BOARD AGENDA FACT SHEET

SUBJECT: Public hearing to consider Appeal #21-0003 of the November 18, 2021, Planning Commission decision of approval Heber 1 Geothermal Repower Project (Conditional Use Permit #19-0028) to allow for facilities upgrades.

**Re: Appeal of Planning Commission's Approval of Conditional Use
Permit No. 19-0028 for the Heber 1 Geothermal Repower Project**

Figure 1. *Estimated fatalities/km of transmission line regressed on km of transmission line among solar projects analyzed in Smallwood (2020).*

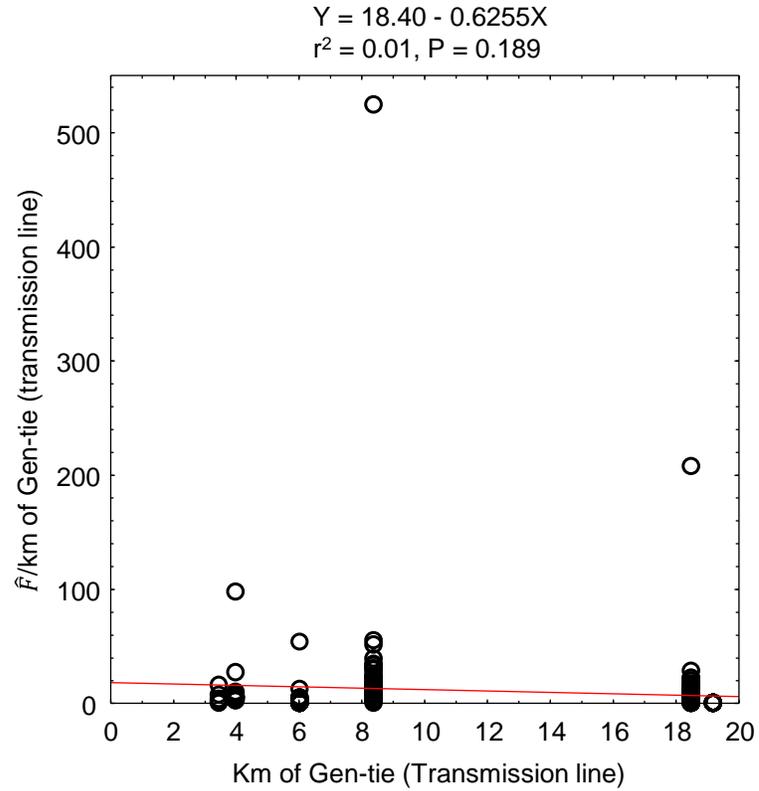
effects of these structures. I regressed estimated fatality rates on the lengths of transmission line and fence used to generate the fatality estimates (Figures 1 and 2). I found no significant effects of length of transmission line nor of the fence on collision fatality rates. My original predictions of collision mortality therefore stand.

County Response 54: The County argues that the solar projects from which I drew collision fatality estimates were green fields, thereby disqualifying them as suitable comparisons to potential impacts at the proposed Heber 1 project, which already exists.

Figure 1. *Estimated fatalities/km of transmission line regressed on km of transmission line among solar projects analyzed in Smallwood (2020).*

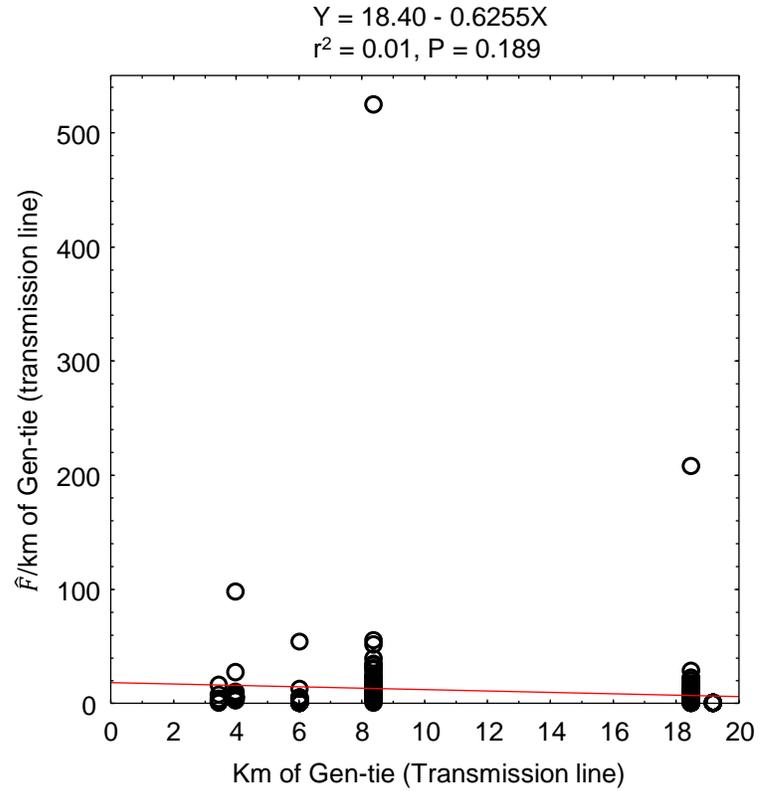
County Response 54: The County argues that the solar projects from which I drew collision fatality estimates were green fields, thereby disqualifying them as suitable comparisons to potential impacts at the proposed Heber 1 project, which already exists.

Reply: The County’s argument is speculative and unsupported. The County’s argument implies that birds habituate to hazards in their airspace. Whether birds habituate to such hazards has been looked into, most often in the context of wind turbine collision mortality. My most recent test of habituation revealed that resident songbirds might show some capacity for habituation when they are assisted by contrast painting of the structures that pose the hazard, but not migrants nor raptors (K. S. Smallwood, unpublished data). Without the assistance of contrast painting, fatality rates continued unchanged for years, and showed no change other than reflections of multi-annual cycles of abundance unique to each species.
